TSG RAN Meeting #25 **RP-040288**
Palm Springs, US, 7 - 9 September 2004

Title **CRs (Rel-6) to TS25.101 & TS25.133 for WI "Technical Enhancements and Improvements"**
Source **TSG RAN WG4**
Agenda Item **8.8**

⌘ **25.101** **CR** **358** ⌘ **rev** ⌘ Current version: **6.4.0** ⌘

Title:	⌘	Clarification to change of TFC and compressed mode time mask diagrams
Source:	⌘	RAN WG4
Work item code:	⌘	TEI6
Date:	⌘	30/08/2004
Category:	⌘	**F**
Release:	⌘	Rel-6

Figure 6.2: Transmit ON/OFF template for PRACH preambles and CPCH preambles

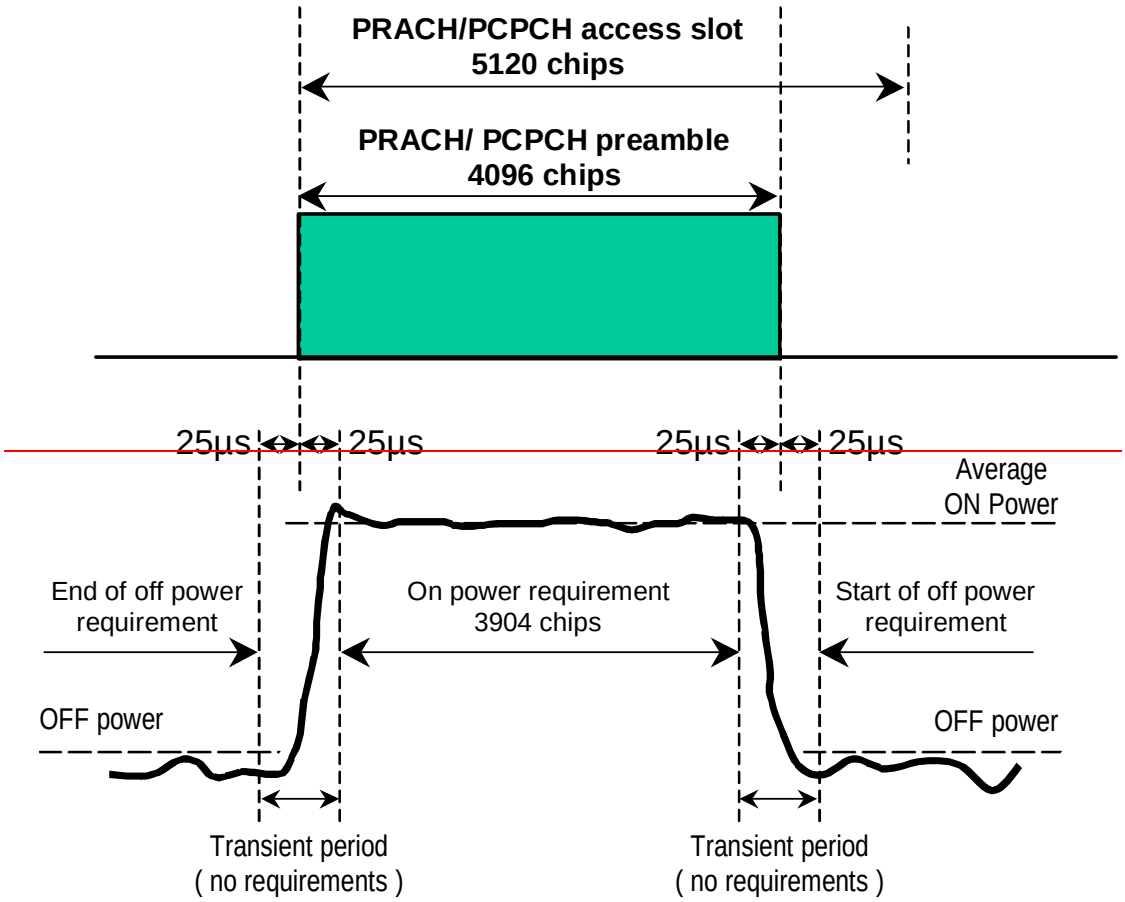
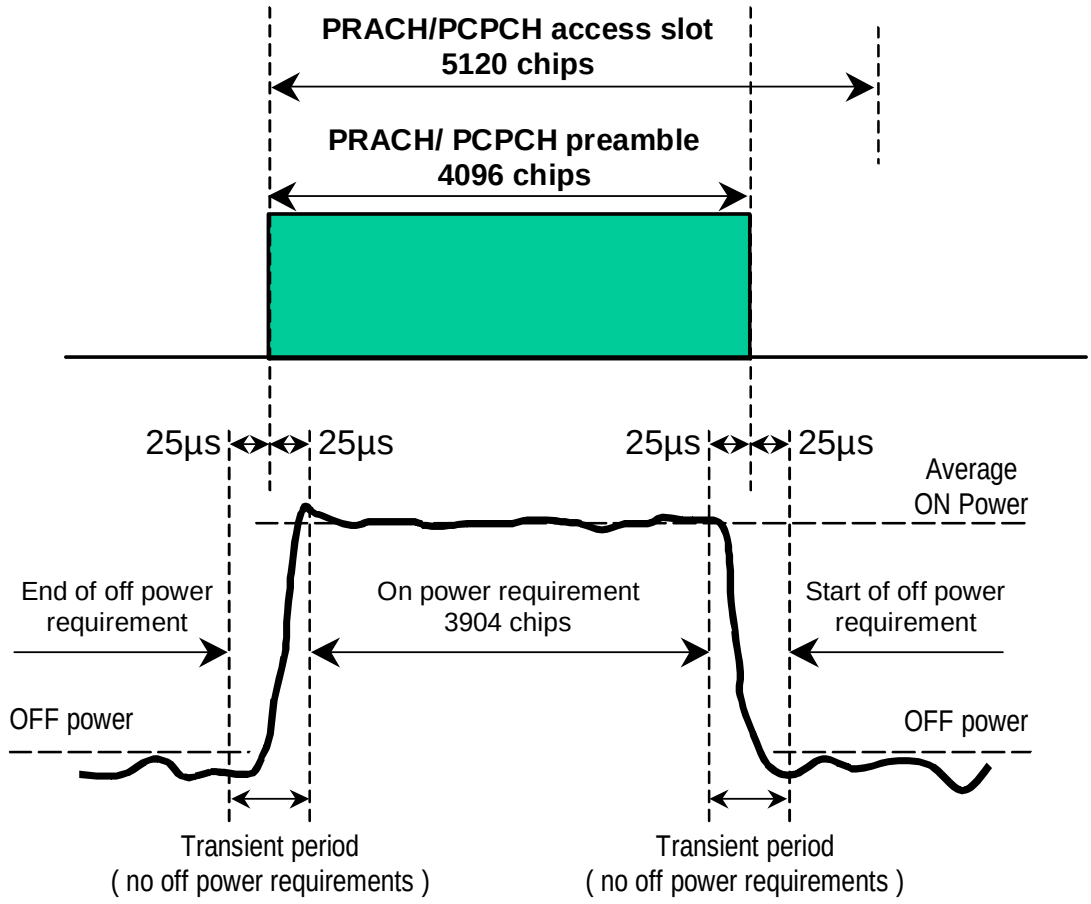
Reason for change:	⌘	The diagrams for the Power time mask have caused confusion due to the implication that there is a maximum and minimum mask power requirement.
Summary of change:	⌘	The diagrams and accompanying text are modified to show the correct relationship between the nominal bursts and the on and off power requirements. In figures 6.2 and 6.3 the transient period comment introduced in v 6.4.0 has been clarified from “no requirements” to “no off power requirements”.
Consequences if not approved:	⌘	Confusion over the definition of the UE power vs. time profile may lead to incorrect implementation and tests.

The transmit power levels versus time shall meet the requirements in figure 6.2 for PRACH preambles and CPCH preambles, and the requirements in figure 6.3 for all other cases. The off power observation period is defined as the RRC filtered mean power in a duration of at least one timeslot excluding any transient periods. The on power observation period is defined as the mean power over one timeslot excluding any transient periods. For PRACH/PCPCH preambles, the on power observation period is 3904 chips (4096 chips less the transient periods).

Figure 6.4: Transmit template during TFC change

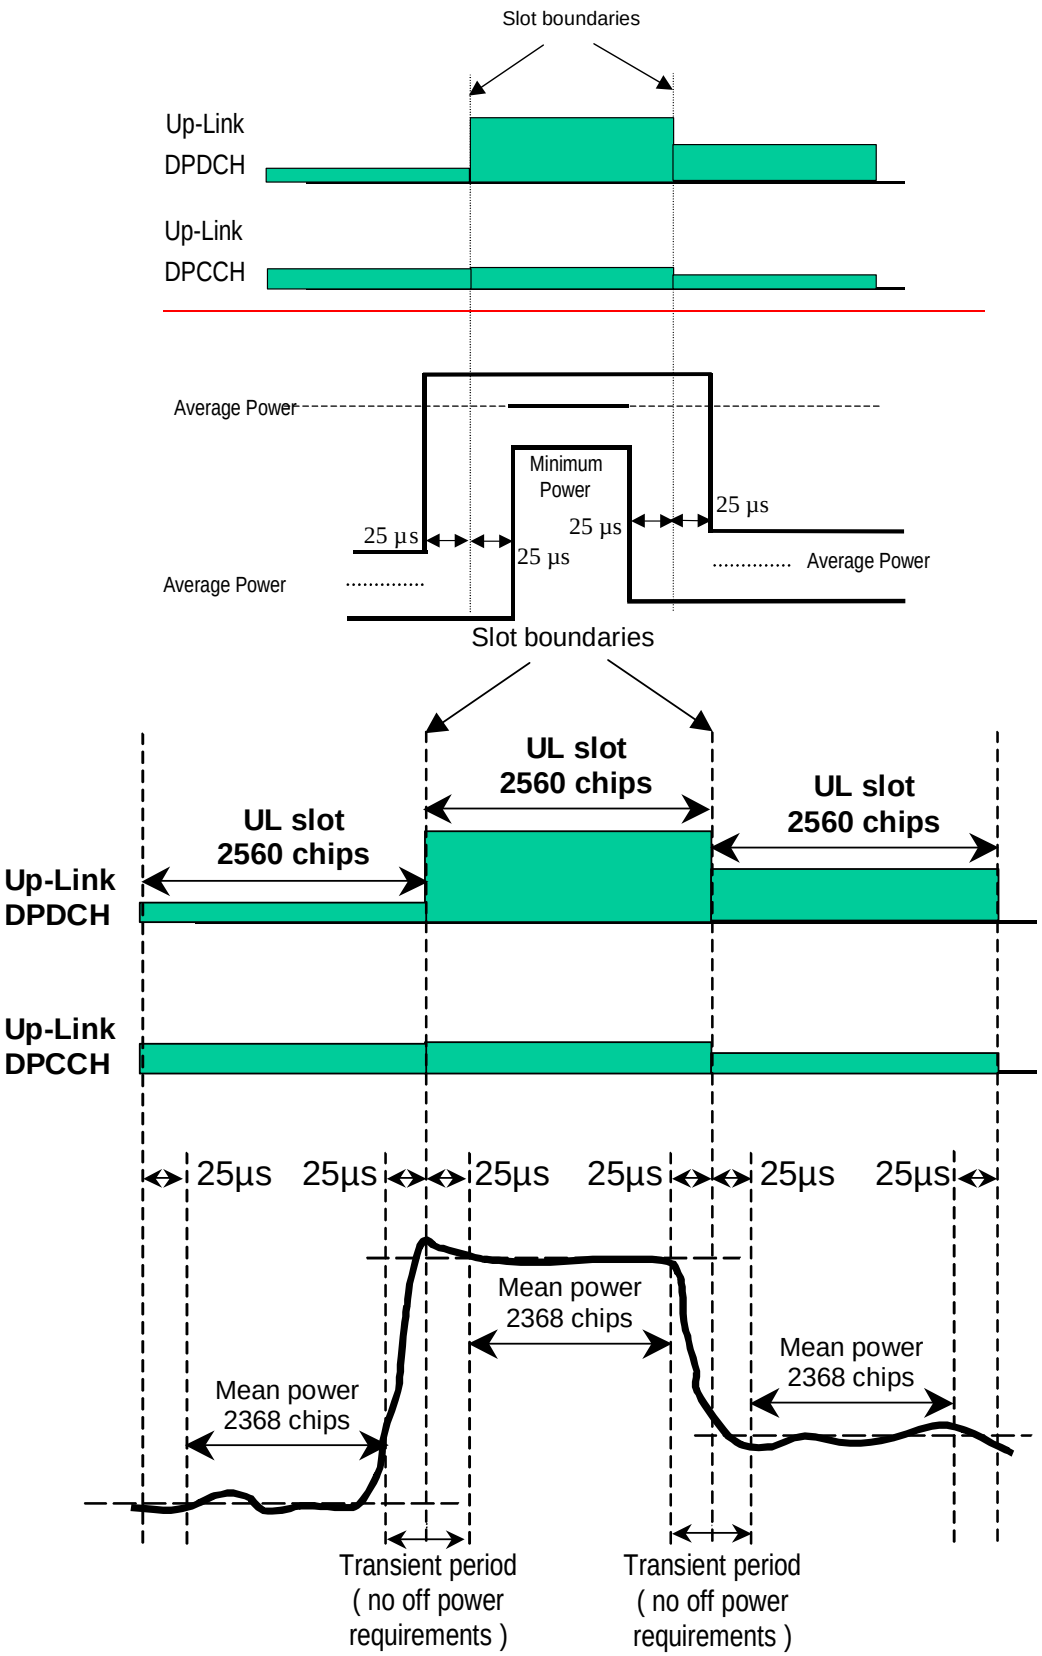
The mean power of successive slots shall be calculated according to ~~transmit power levels versus time shall meet the mask specified in~~ Figure 6.4.

Figure 6.5: Transmit template during Compressed mode

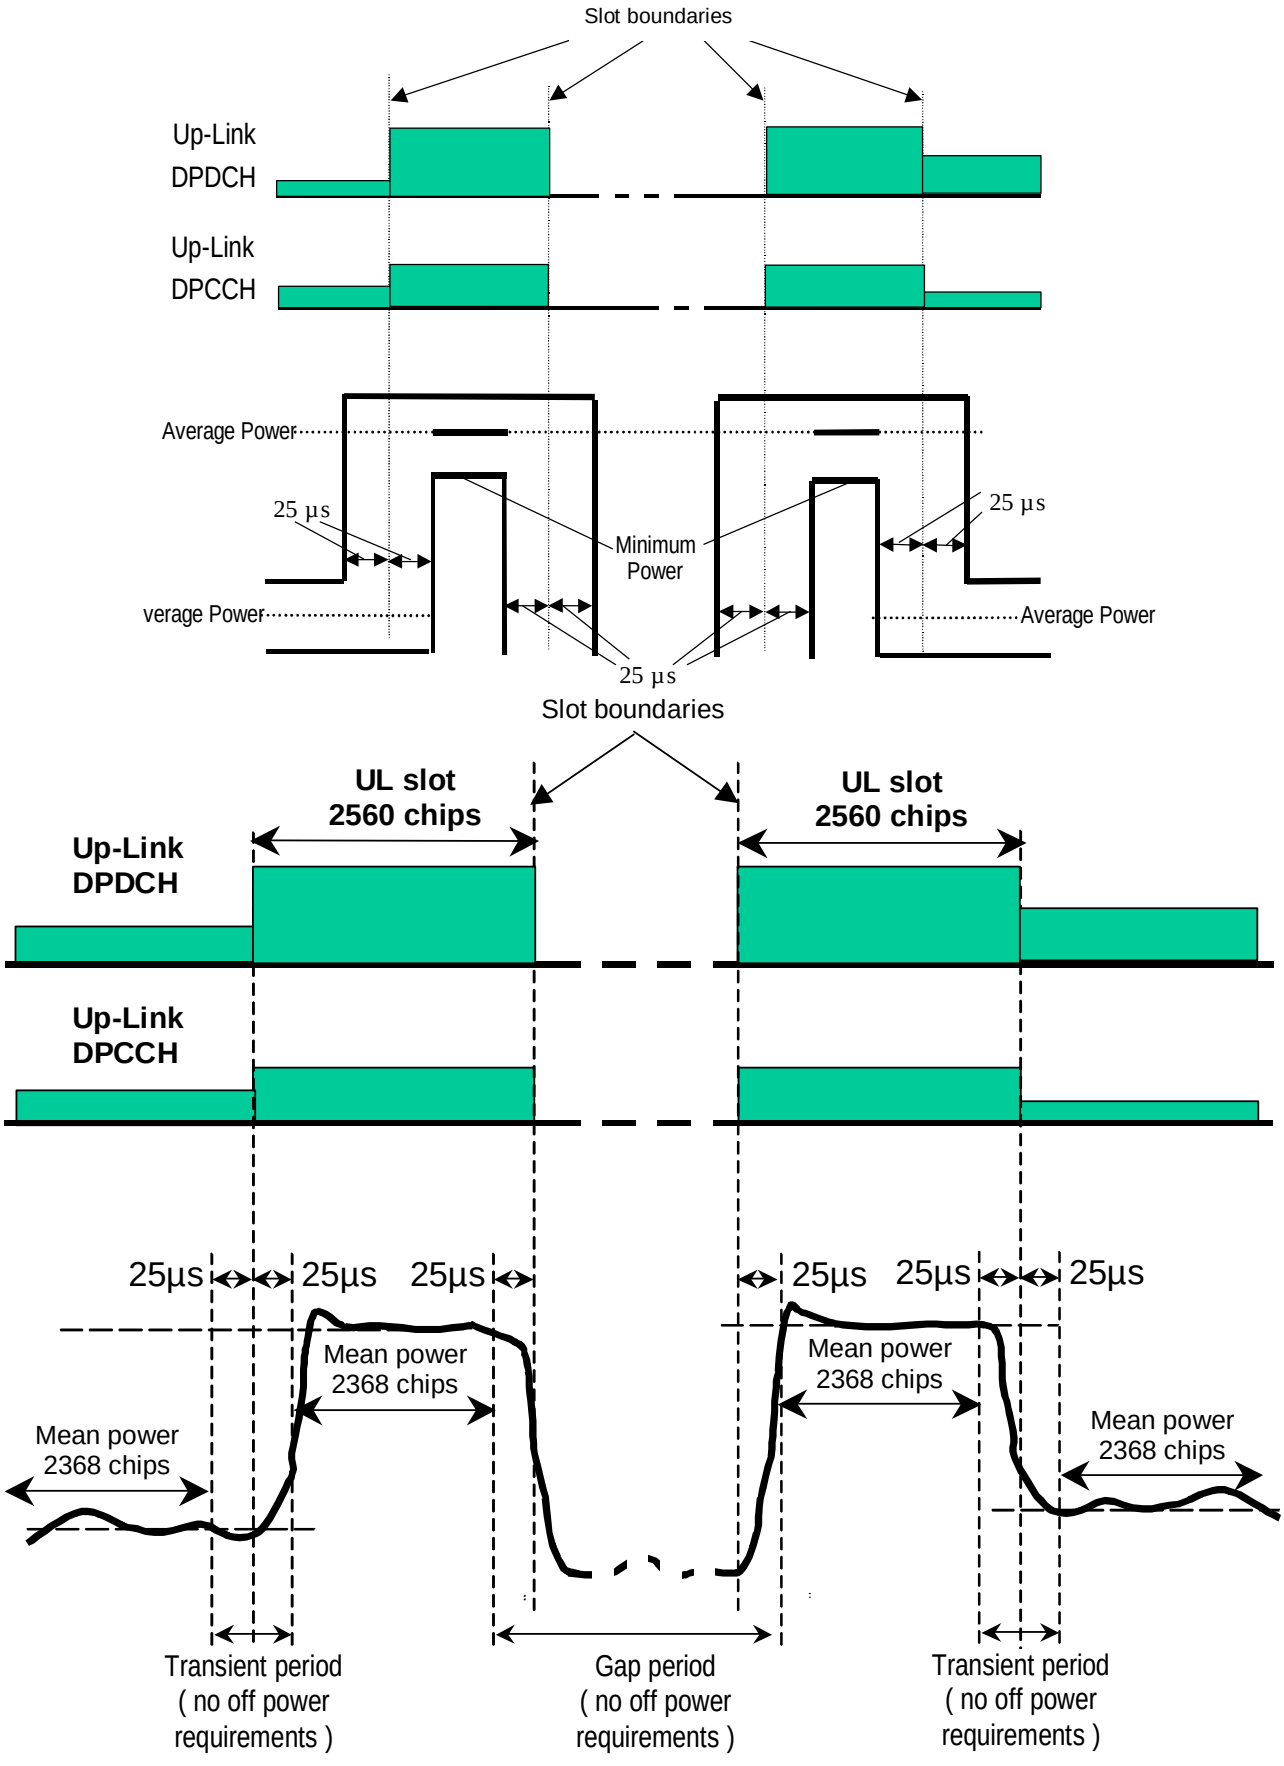
The mean power of successive slots shall be calculated according to ~~transmit power levels versus time shall meet the mask specified in~~ figure 6.5.
